**SANITARY SEWER PLANS FOR  
MONARCH LANDING ADDITION  
PHASE 1**

**LINES 7 & 8**  
SHEET TITLE  
468-84317  
PROJECT NUMBER

SHEET NO.  
**11 of 20**

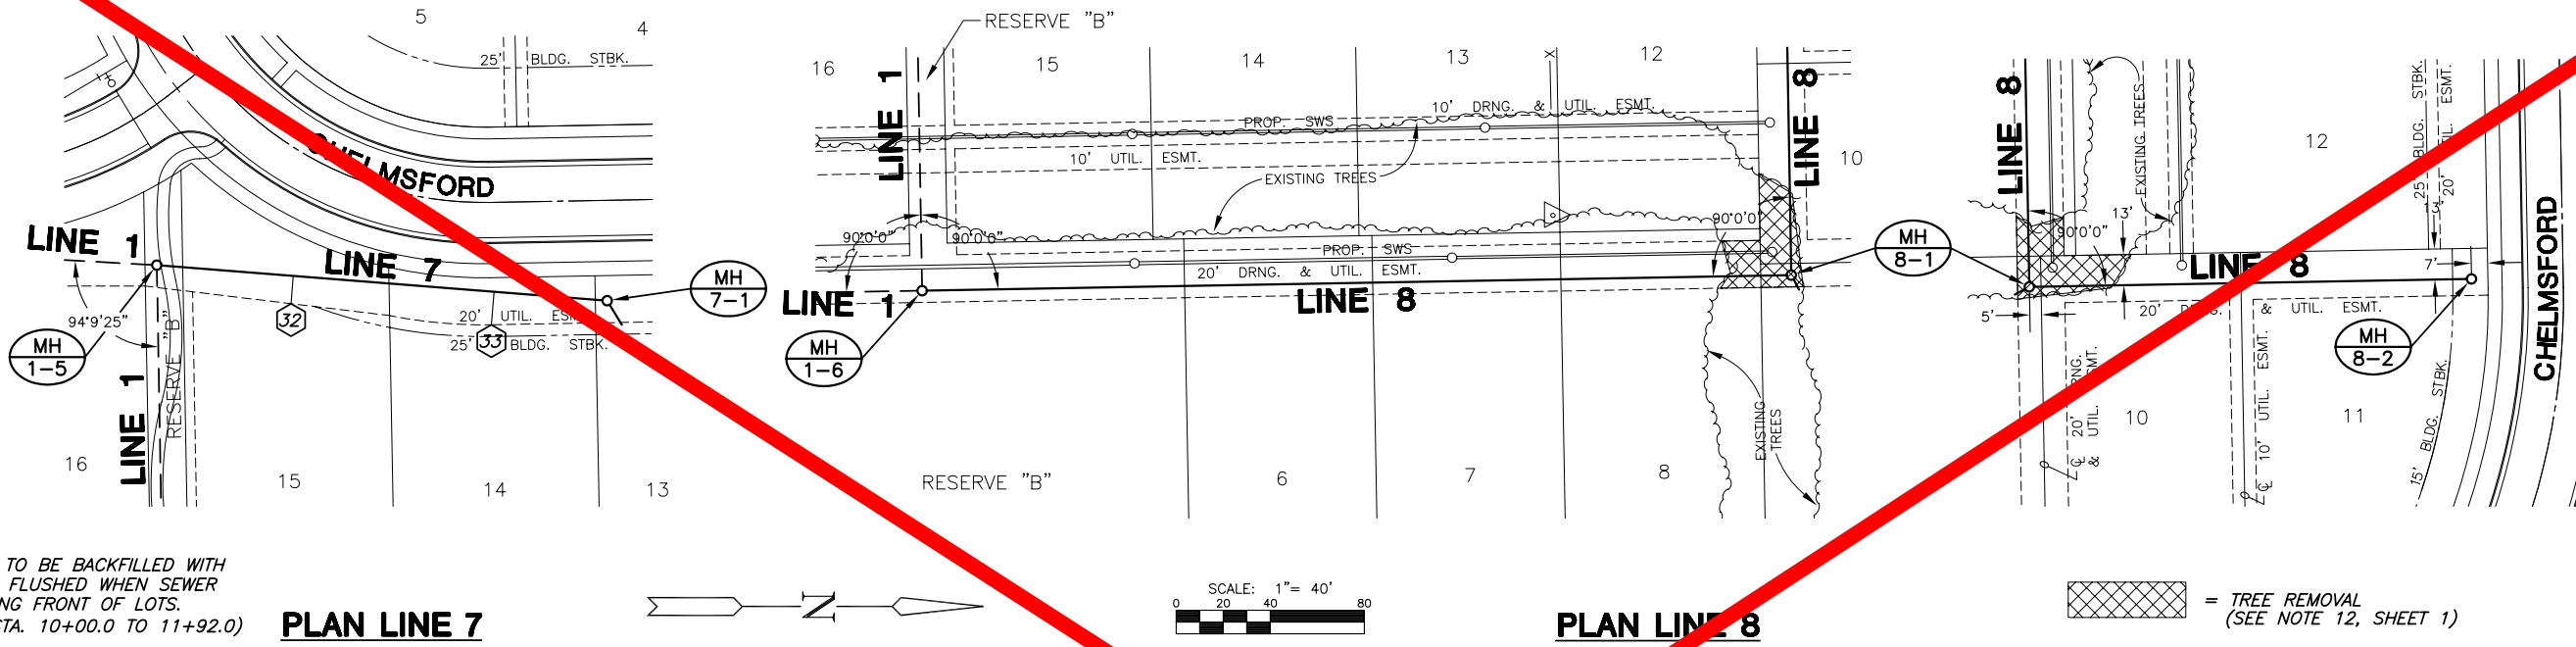
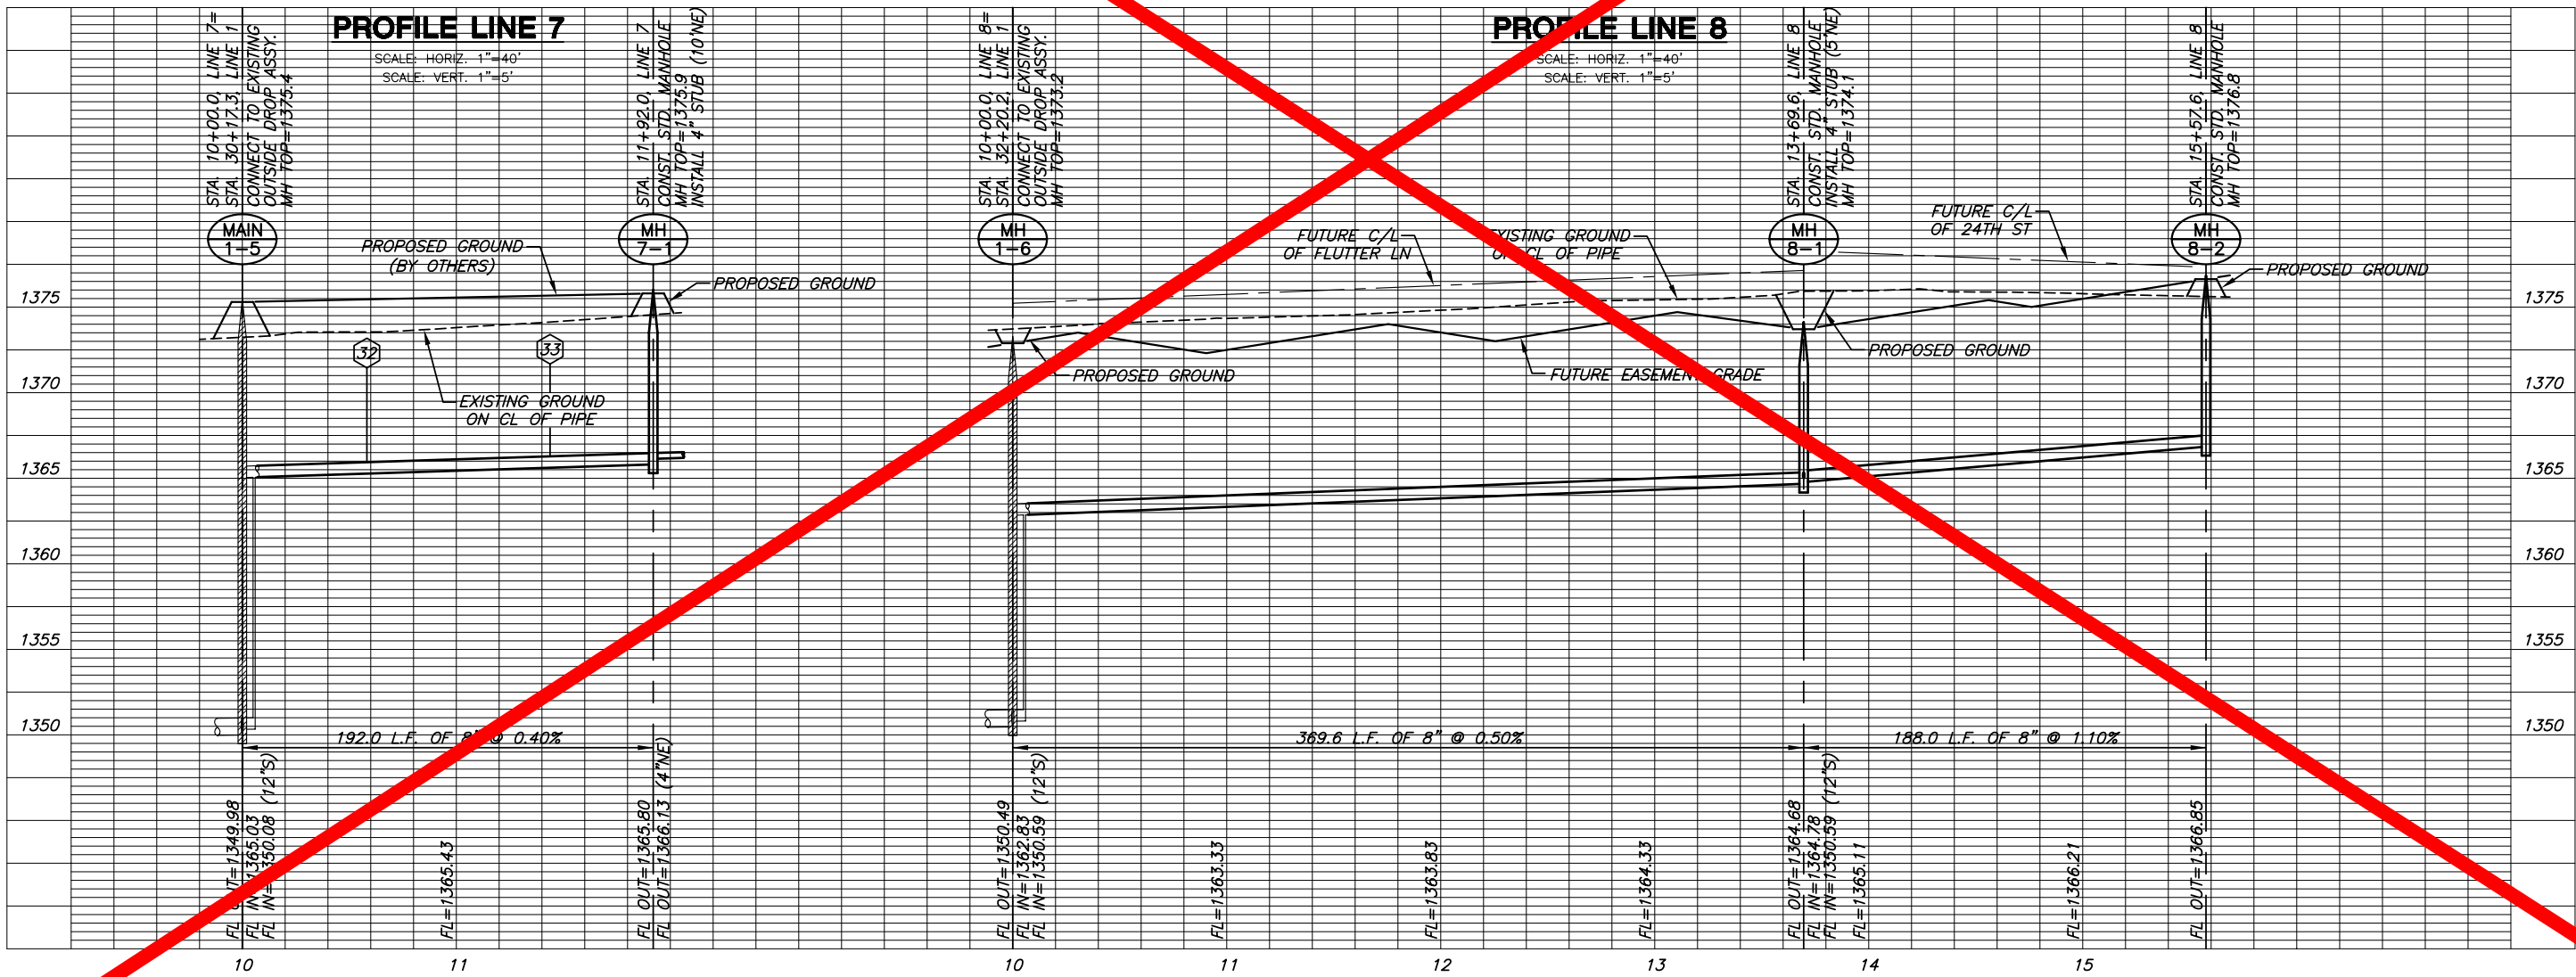
# SEE REVISED SHEET
